IMPORTANT SAFETY RECALL 140016 (NHTSA RECALL NOTICE 14V-746)

This recall applies to your light tower trailer within the following Model(s) and Serial Numbers:

Date: December 18, 2014

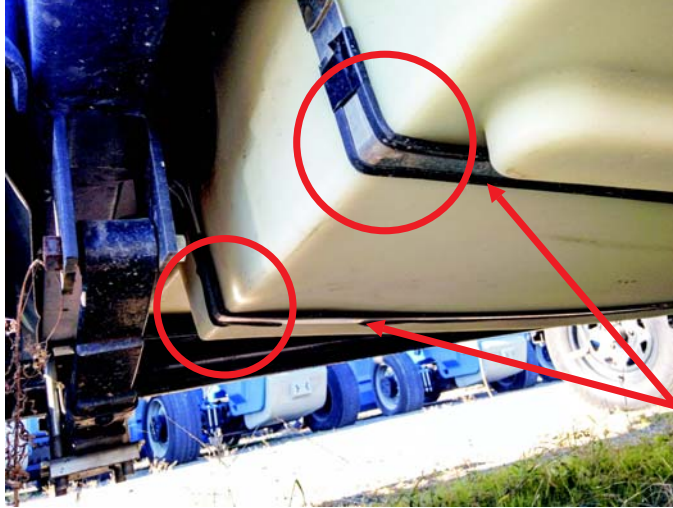
Do not tow the trailer if any of the following conditions is observed.

- Fuel tank is in constant contact with the axle.
- Fuel tank is sagging in such a way that it intermittently contacts the axle during towing.

The light tower can still be used in a stationary position if no fuel leak is observed.

Photo 1

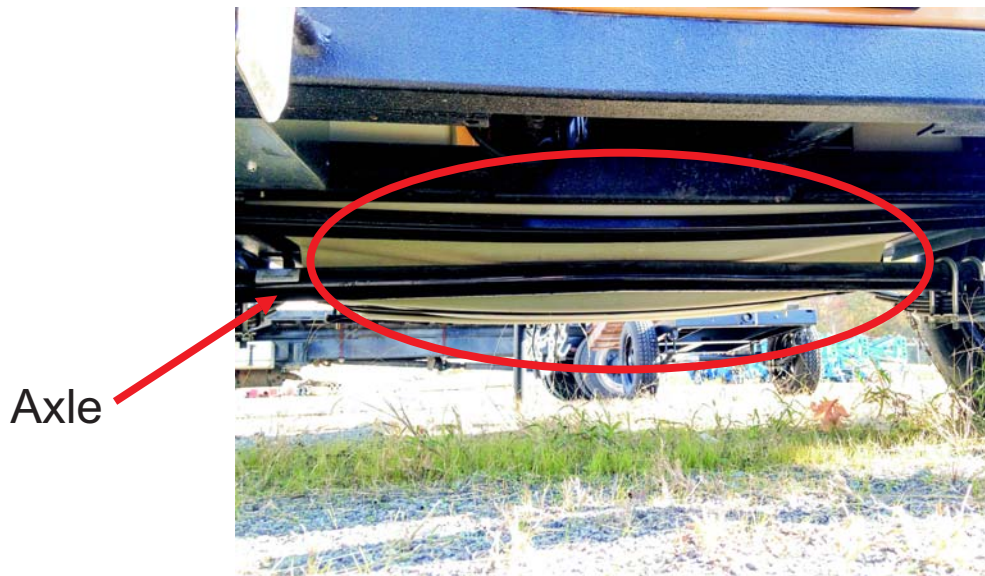
If the fuel tank strap has permanently deformed the tank by 0.25 inches at the bottom corner of the tank, the tank should be replaced (refer to Photo 1). Order the replacement tank (PN 162368) along with the fuel tank support kit and destroy the damaged fuel tank.
